RE: Response to Request for Additional Information

Project Name: Riopelle-Ariana Farms - Rezoning
Application No.: H-25-26

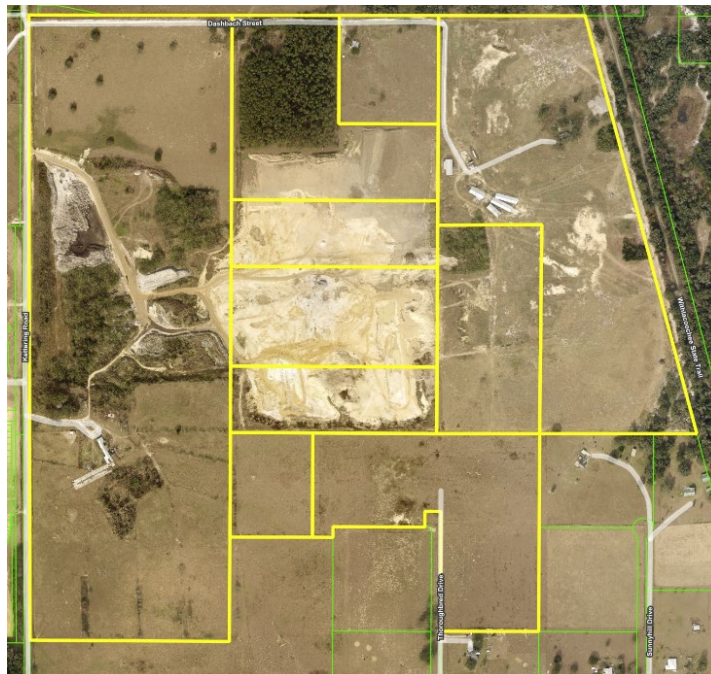
Pedestrian connectivity is needed to connect the various pods.

Response: Confirmed. Pedestrian Connectivity will be met through internal sidewalks. All internal Sidewalks will connect to the Park/Amenity Areas. An optional pedestrian connection to the

Withlacoochee State Trail to the east has also been added to the Master Plan within the Park/Amenity Area that connects to the eastern boundary.
